**NYS DOT Champlain Hudson Power Express ("CHPE")
Environmental Management & Construction Plan
Notice of Major Change**

Project: Champlain Hudson Power Express

Segment: 8

Notice Number: 141

PERMIT DRAWING NO. **N/A**
DRAWING NO. **C-107**

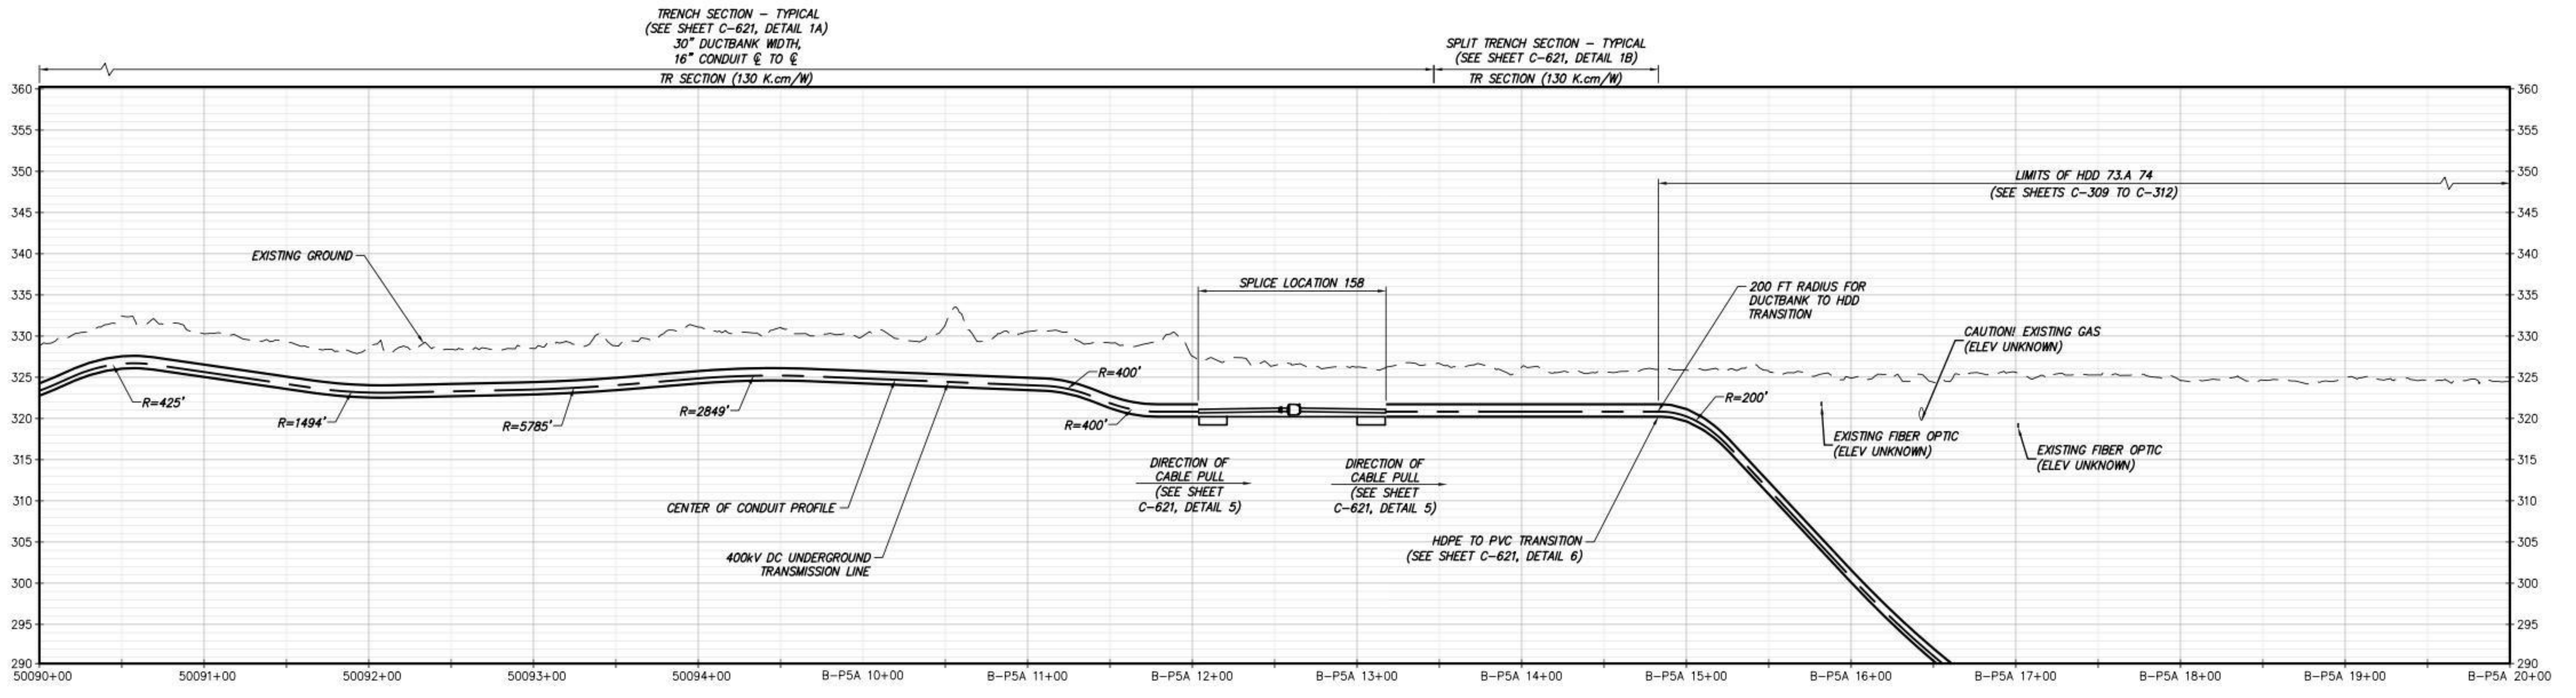
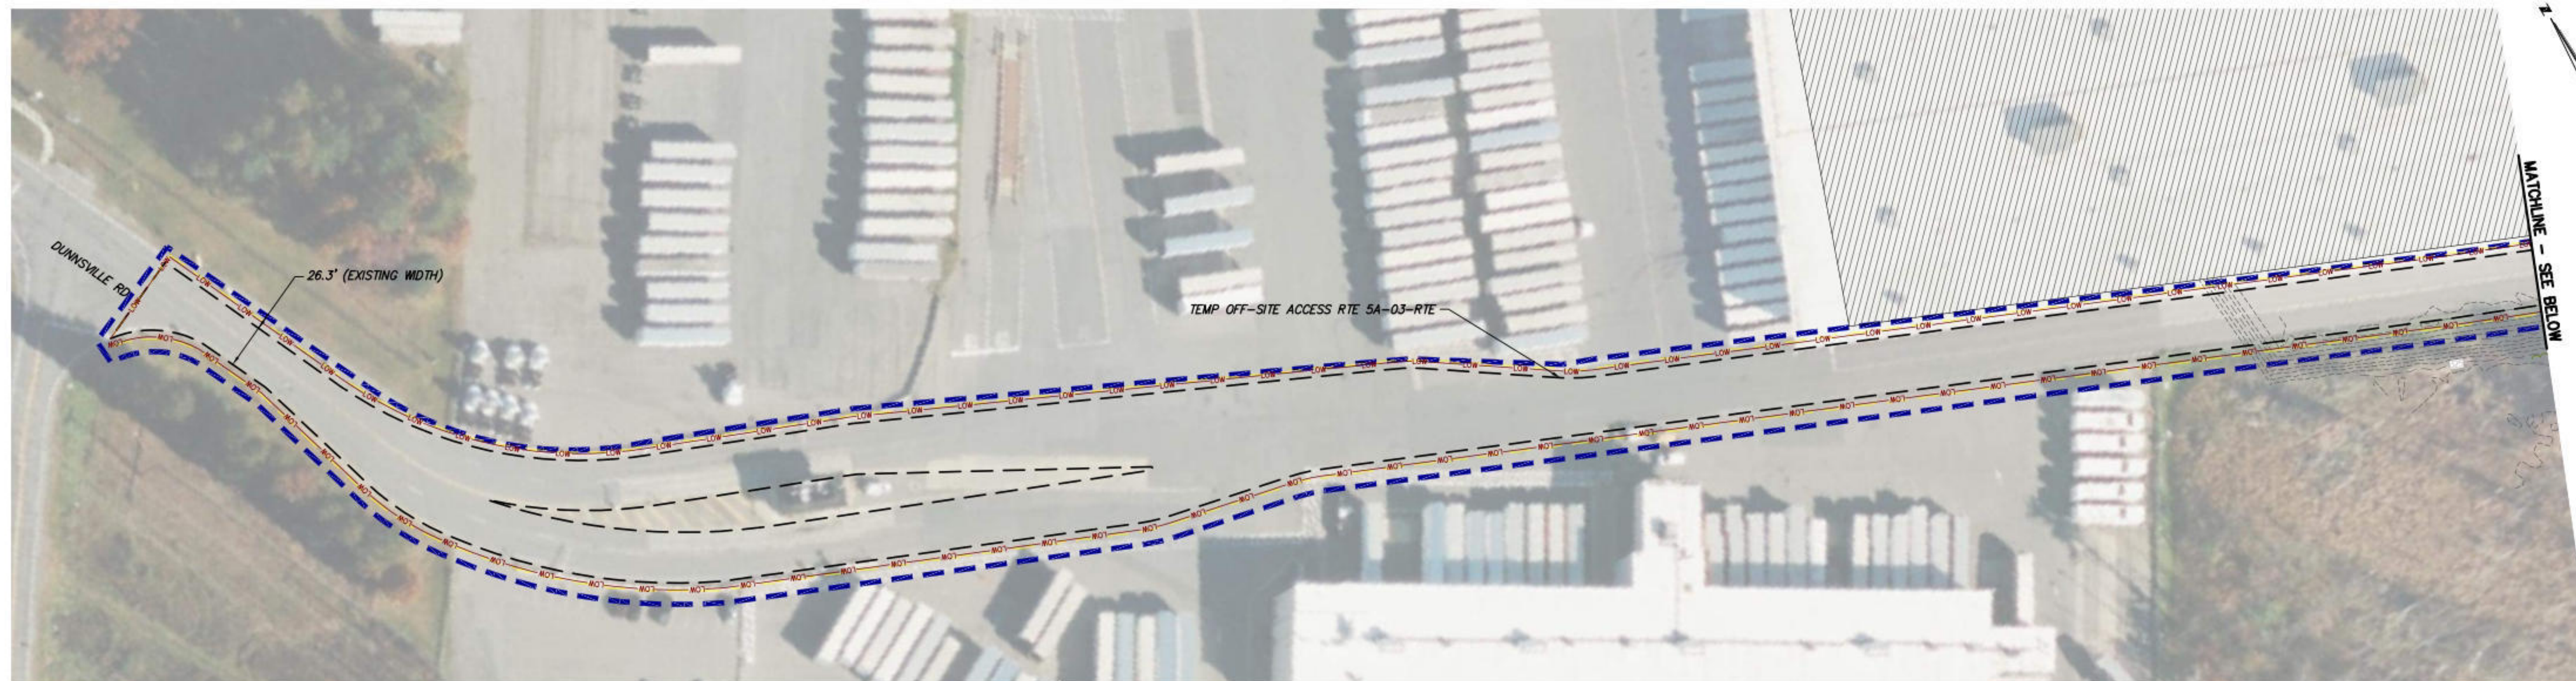
C-107	2	NDC-0049: HDD 73 Extension on Golub Property	Secondary access point added from Golub Corporation Property per coordination with Golub Corporation and CHPE LLC.
C-213	1	NDC-0049: HDD 73 Extension on Golub Property	Secondary access point added from Golub Corporation Property per coordination with Golub Corporation and CHPE LLC. Access revised accordingly for connection and security.
C-213.1	0	NDC-0049: HDD 73 Extension on Golub Property	New Sheet: Secondary access point added from Golub Corporation Property per coordination with Golub Corporation and CHPE LLC. Access revised accordingly for connection and security.
C-307	1	NDC-0049: HDD 73 Extension on Golub Property	HDD 73 realigned for extension on Golub Corporation Property and to increase clearance from Duanesburg Road Bridge abutment. HDD 73 Work area revised (enlarged) to accommodate extension of

PERMIT DRAWING NO. **N/A**
DRAWING NO. **C-307**

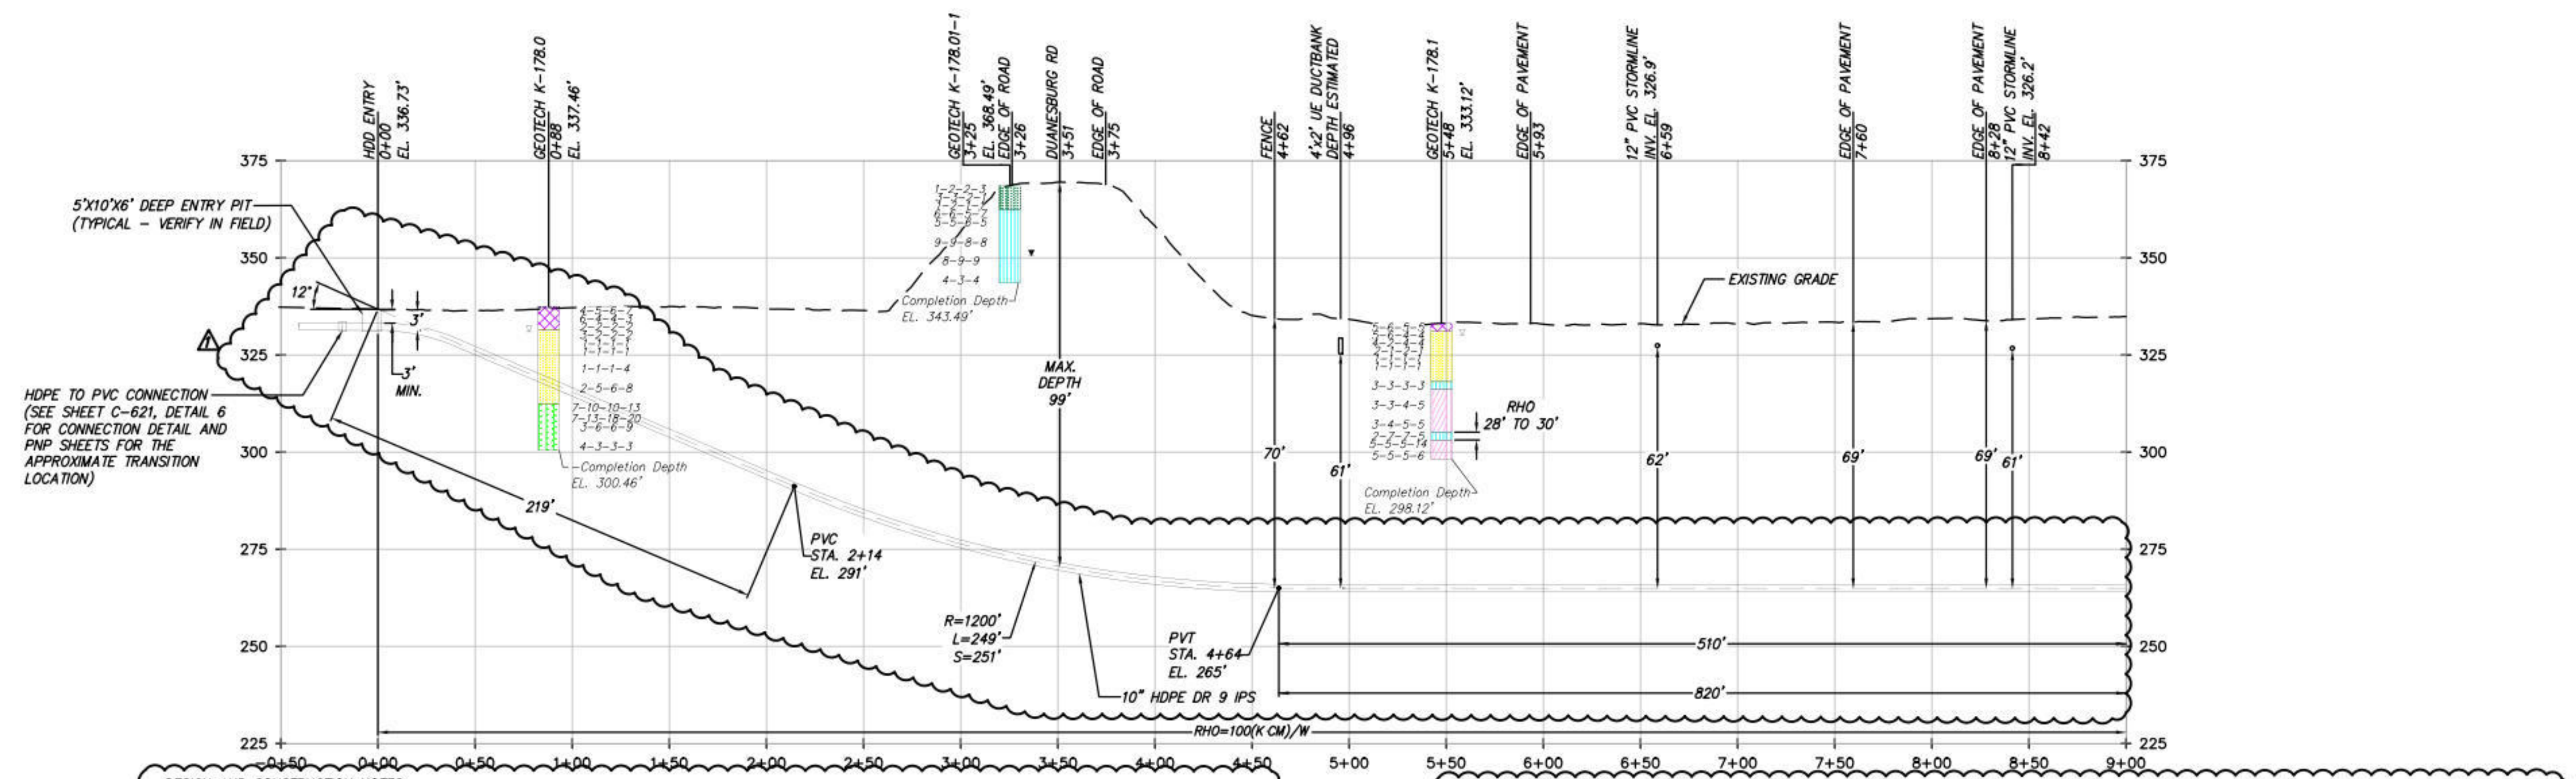
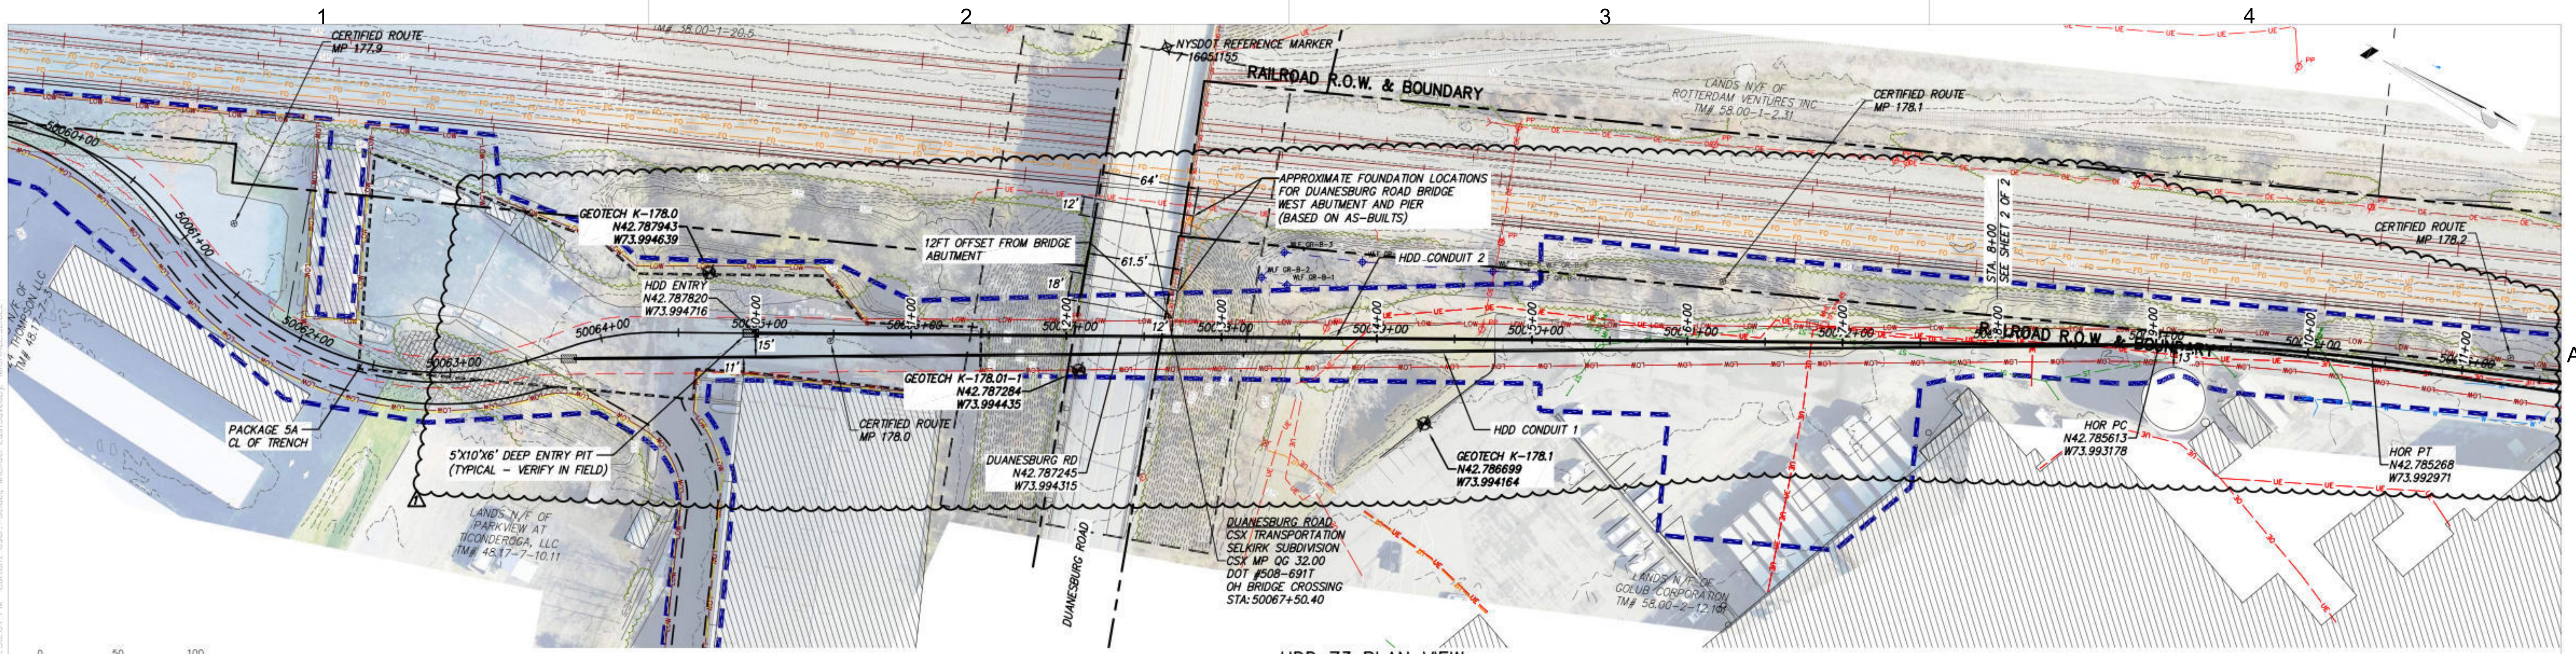
HDD. HDD pits were relocated and offset to maintain required spacing. HDD profile added to sheet. The approximate Duanesburg Road Bridge Abutments were added in plan view along with clearance callouts consistent with NYSDOT coordination. Callouts were added for clearance to Golub Corporation Water Tank and utilities in profile. Added all "Design and Construction" and "General Notes".
C-307.1	0	NDC-0049: HDD 73 Extension on Golub Property	New Sheet: HDD 73 realigned for extension on Golub Corporation Property. HDD work area relocated from C-307 to C-307.1 as a result of HDD 73 extension and based on coordination with Golub Corporation and CHPE LLC.
C-308	1	NDC-0049: HDD 73 Extension on Golub Property	HDD 73 realigned for extension on Golub Corporation Property and to increase clearance from Duanesburg Road Bridge abutment. HDD 73 Work area revised (enlarged) to accommodate extension of HDD. HDD pits were relocated and offset to maintain required spacing. HDD profile added to sheet. The approximate Duanesburg Road Bridge Abutments were added in plan view along with clearance callouts consistent with NYSDOT coordination. Callouts were added for clearance to Golub Corporation Water Tank and utilities in profile. Added all "Design and Construction" and "General Notes".
